December 15, 2021

**Re:        Second Submission Review:**    1900 S Chambers Community Lot 1 - Site Plan Amendment  
          **Application Number:**            DA-2105-01  
          **Case Numbers:**                 2018-6020-03

Please use this cover letter as a guide for the Second Submittal of 1900 S Chambers Community Lot 1 – Site Plan Amendment. The following pages detail the response to your comments, and no major changes have occurred since the previous submittal. If you have any comments or concerns, please give call or email me. I may be reached at 817.687.8846 or [gbogdanoff@pnt-llc.com](mailto:gbogdanoff@pnt-llc.com).

**B SITE SCAPES CITYVIEW TRASH RECEPTACLE**

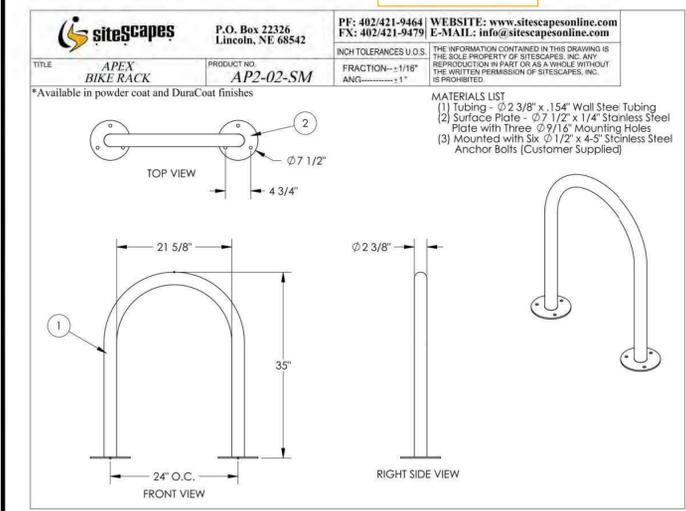
add note: All proposed landscaping within the sight triangle shall be in compliance with COA Roadway Specifications, Section 4.04.2.10'

This note has been added to the landscape detail sheet.

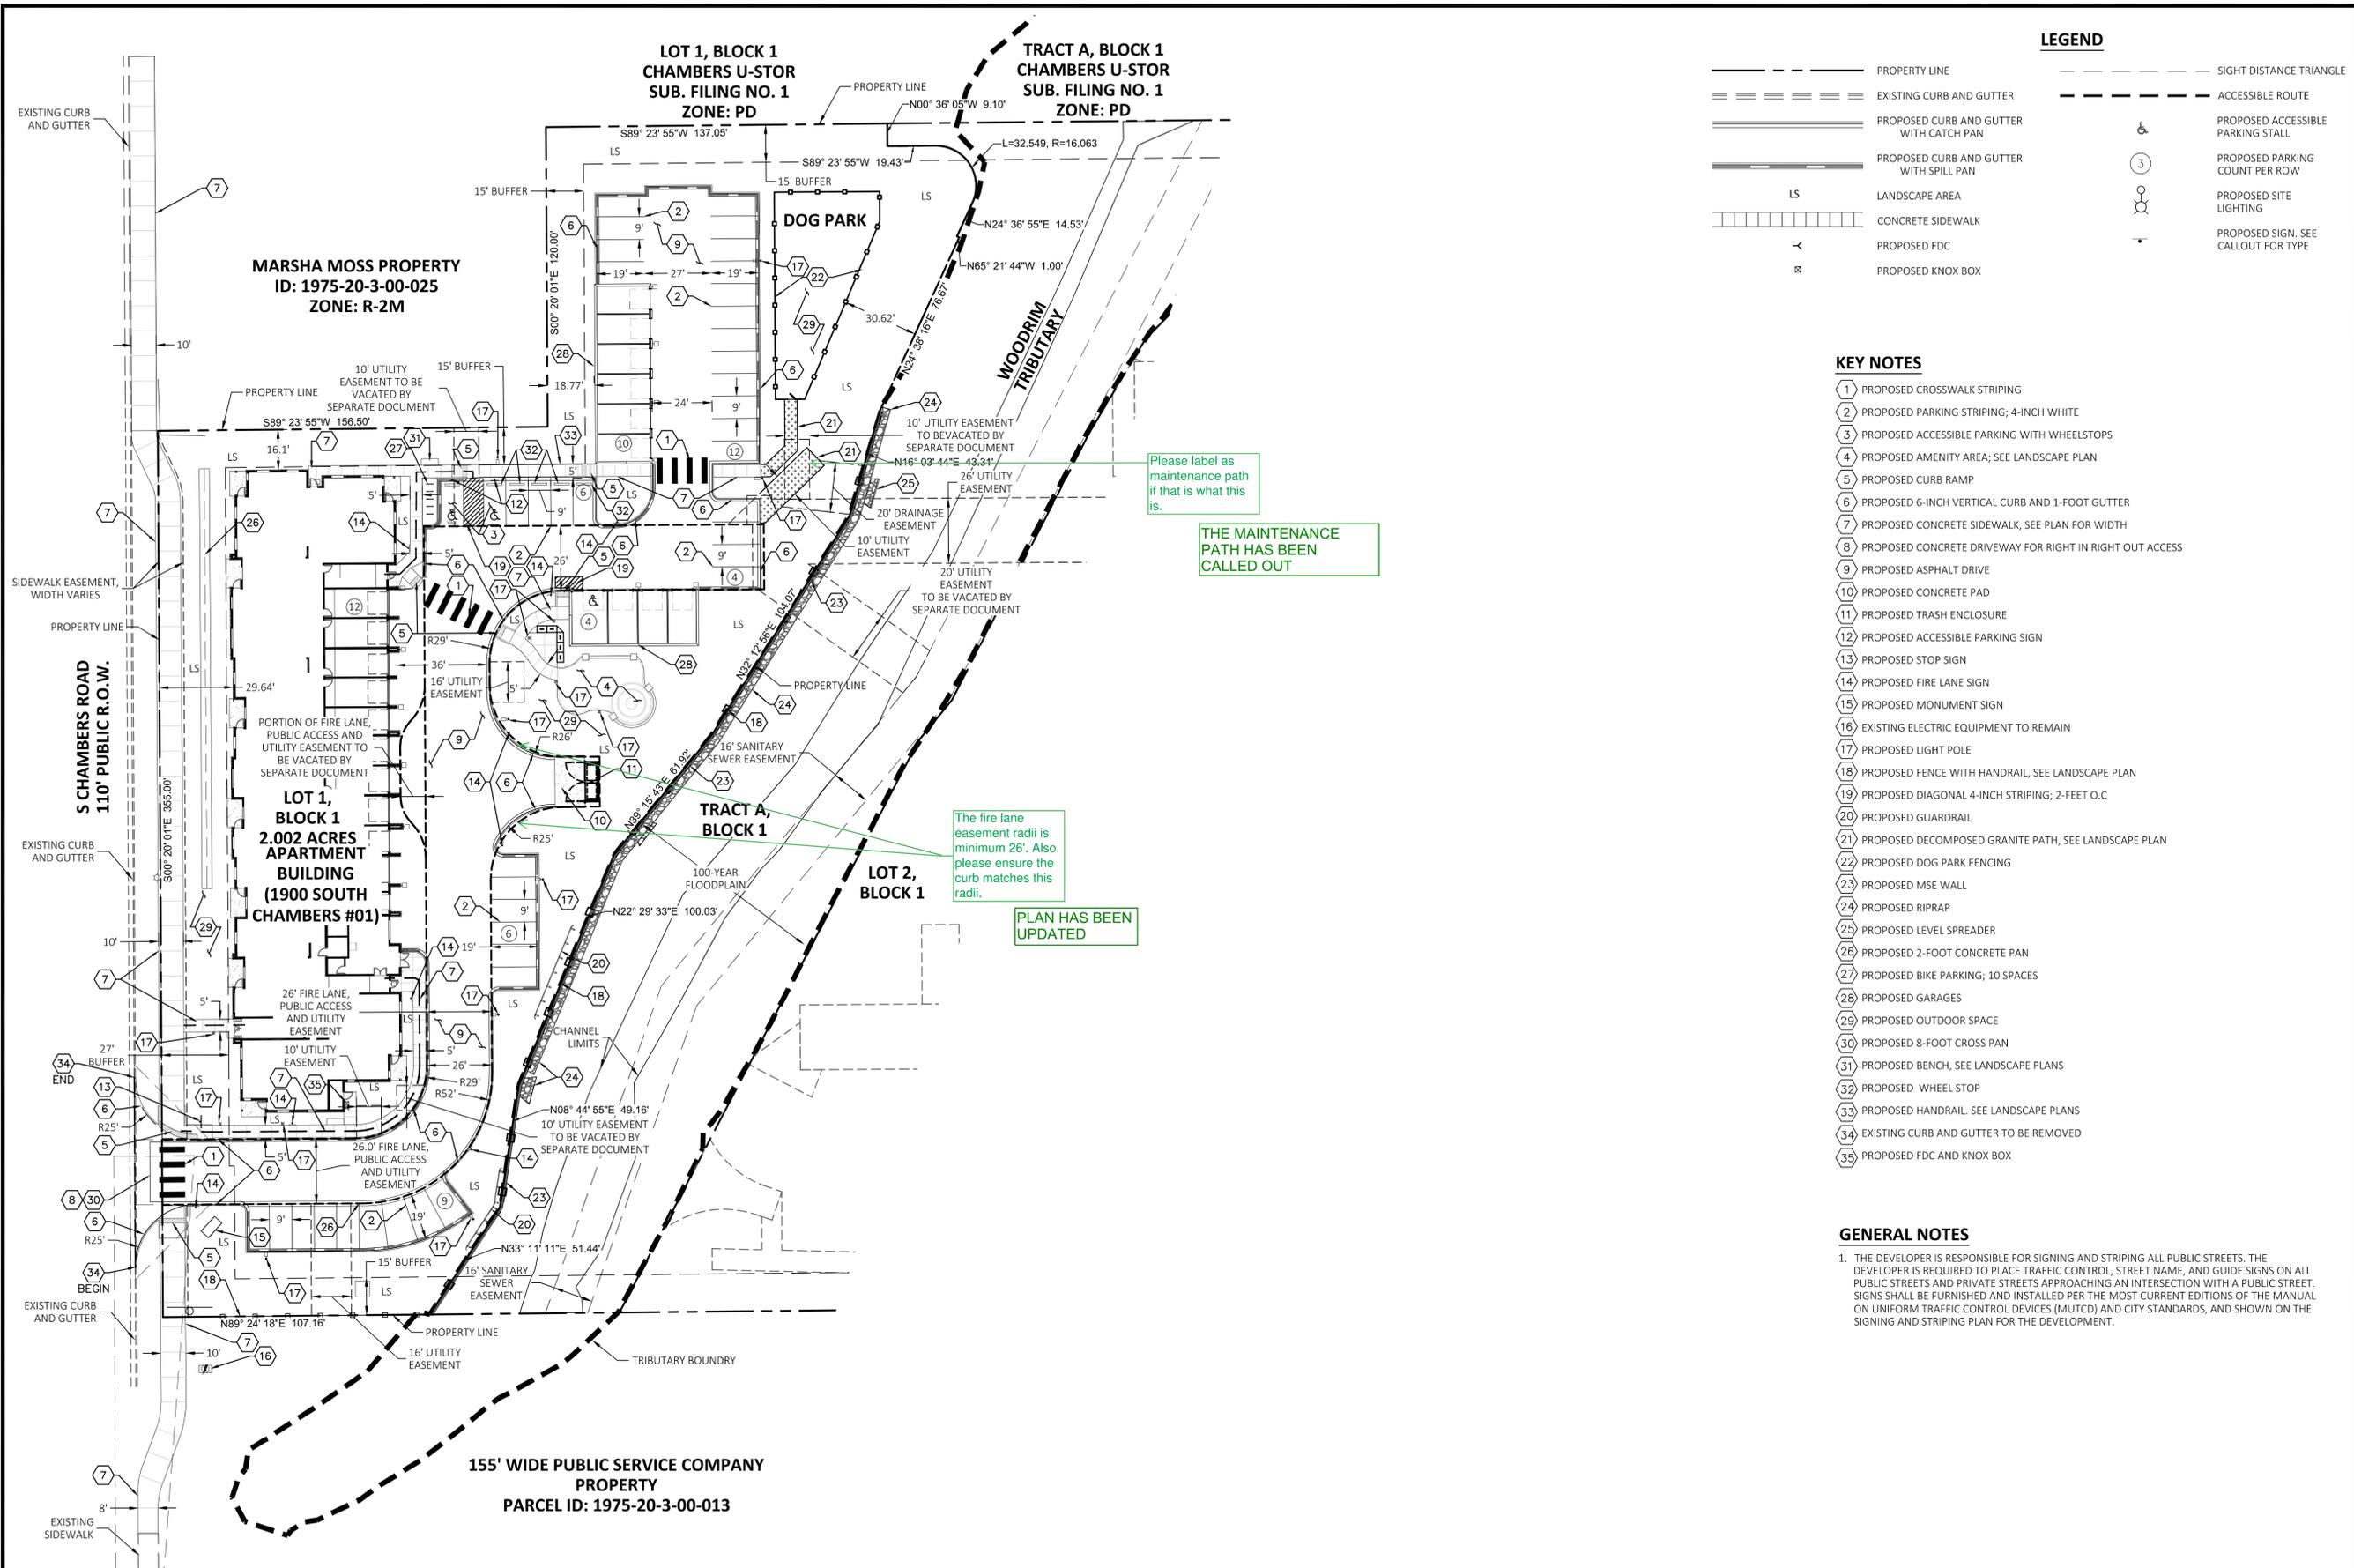
The proposed building length of 257' 5/8" exceeds the maximum building length allowable in Subarea B which is 200 feet. Revise the site plan to meet this requirement. If intend to move forward with the proposed building length you will to request a major adjustment since you are requesting an adjustment to the Development Standards in this UDO. Update your Letter of Introduction to include the request for a major adjustment and your response to criteria for approval identified in Section 146-5.4.4.D.3.

NOTED. A MAJOR ADJUSTMENT WILL BE REQUESTED IN THIS THIRD UMBMITTAL FOR THE BUILDING LENGTH. THE LETTER OF INTRODUCTION WILL ENGAGE THE CODE TO DEFEND THE NEED FOR AN ADJUSTMENT.

SP-1 (2 OF 11)

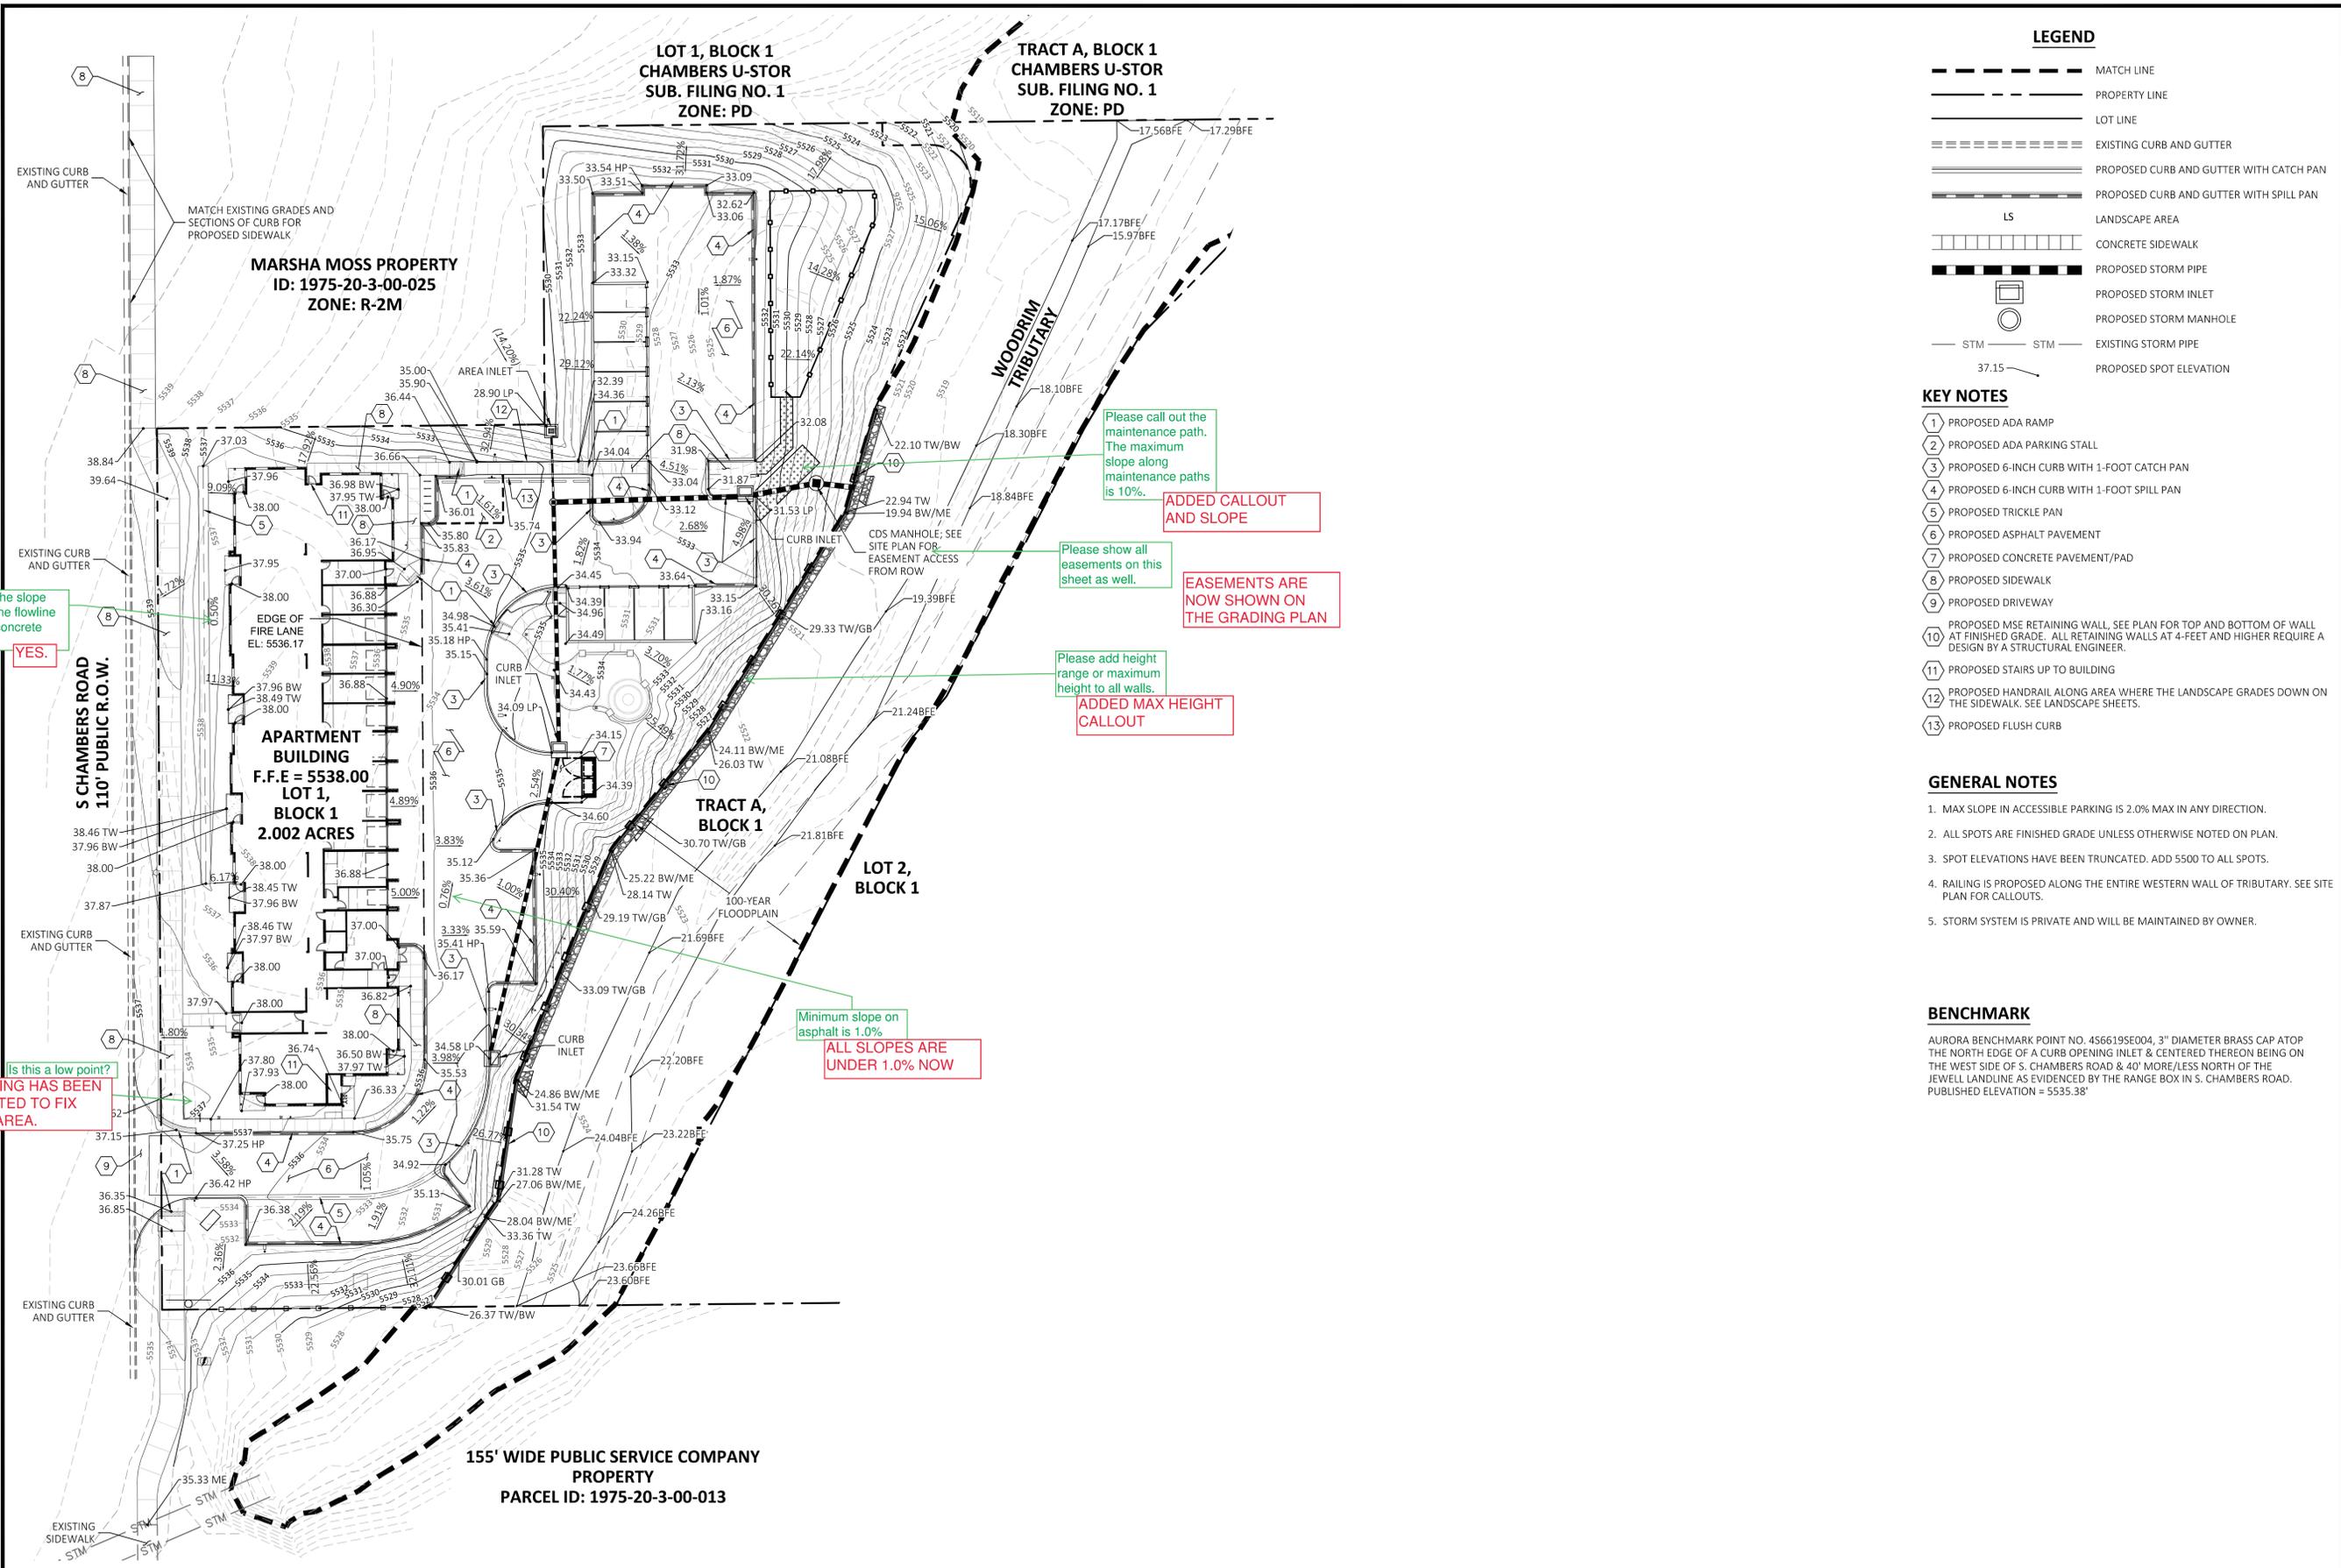
Please label as maintenance path if that is what this is.

The fire lane easement radii is minimum 26'. Also please ensure the curb matches this radii.

THE MAINTENANCE PATH HAS BEEN CALLED OUT

PLAN HAS BEEN UPDATED
